DTSC REVIEW OF "ADDENDUM TO THE NOVEMBER 15, 2013 WORK PLAN FOR THE OFF-SITE SOIL SAMPLING, EXIDE TECHNOLOGIES, VERNON, CA" DATED MARCH 21, 2014, PERSUANT TO STIPULATION AND ORDER, DOCKET HWCA P3-12/13-010, OAH NO. 2013050540, AND CORRECTIVE ACTION CONSENT ORDER, DOCKET NO.:P3-01/02-010

SUBJECT: Technical Review of Addendum to the November 15, 2013
Work Plan for Off-Site Soil Sampling
Exide Technologies, Inc. Site
2700 South Indiana Street
Vernon, California 90058
Prepared by Advanced GeoServices Corp. (AGC)

Exhibit 1

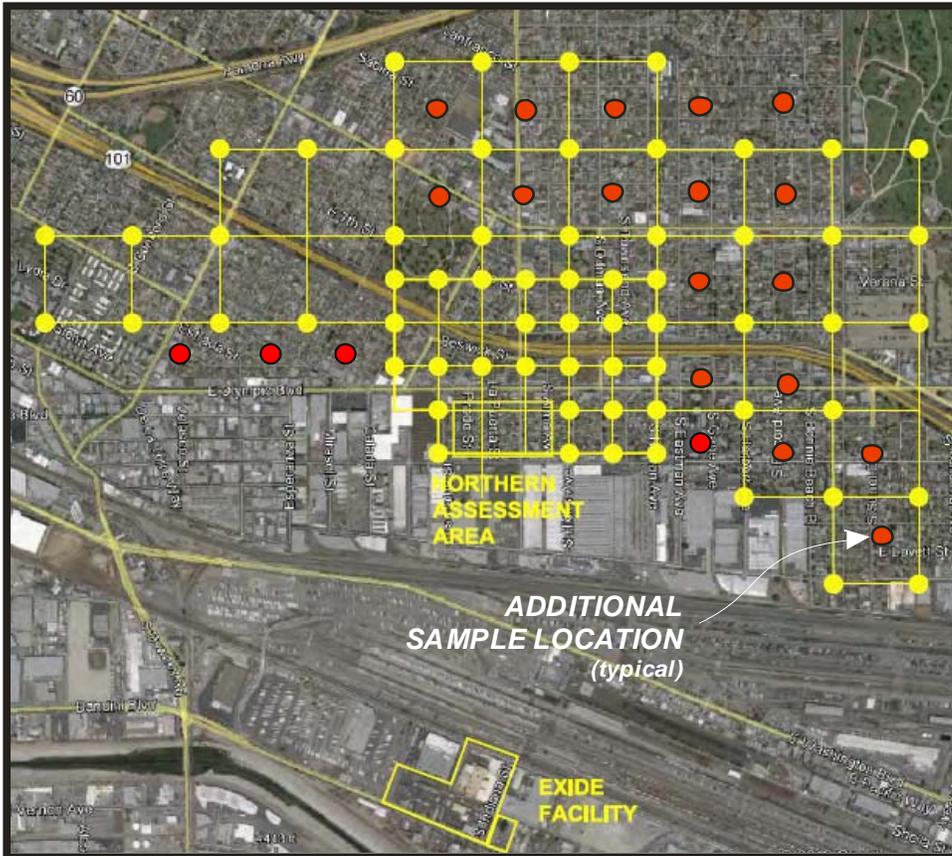
- C) Sample Locations - DTSC requires that the sampling density for the expanded areas be increased to include residences near the nodes (in red)

as depicted on the attached Exhibit 1. All public and private schools (K-12) and public parks within the expanded assessment areas shall be sampled. Sampling in the expanded assessment areas shall be consistent with the sampling protocol for the Northern and Southern Assessment Areas. In addition, should DTSC be contacted by any resident wishing to have their property soils tested for lead within 2,000 feet of the boundaries of the proposed expanded assessment areas, Exide shall sample and test that residential property in accordance with the approved sampling criteria.
